Service Bulletin

Service Bulletin: No. 412-200

Removal and Installation - 412AC-300 Air Conditioning System

Compressor Pivot Bolts.

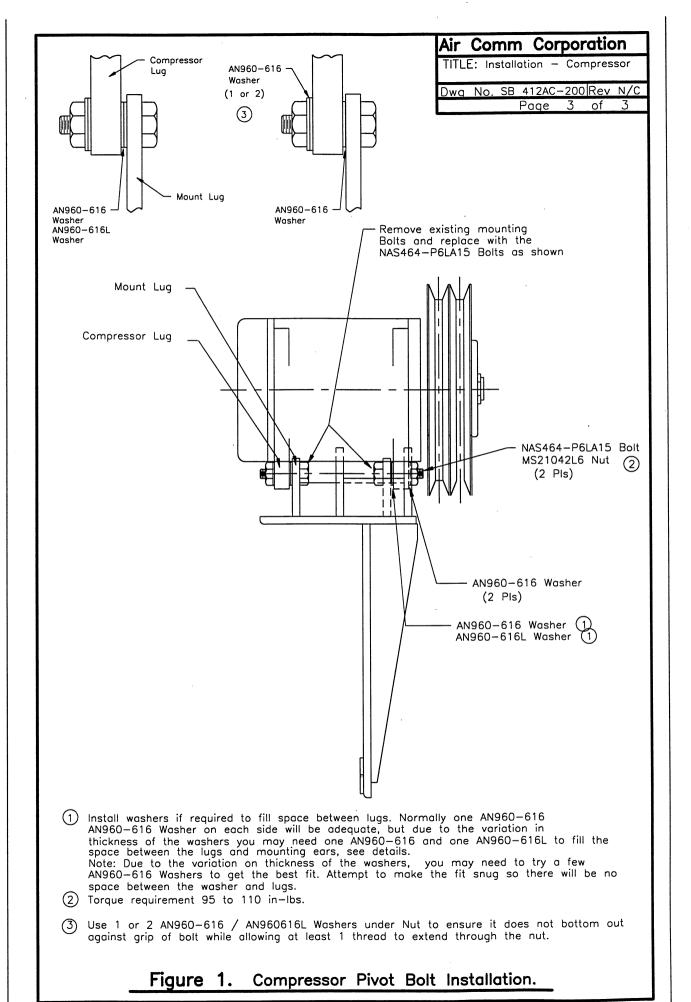
It has been determined that the compressor mounting pivot bolt length is too short. Also a bolt torque callout is required.

Remove and replace the existing Compressor Mount Pivot bolts as shown in figure 1.

Torque the pivot bolt nuts to the specified torque.

Inspect the compressor lugs and compressor mount for evidence of wear, cracks and overall security.
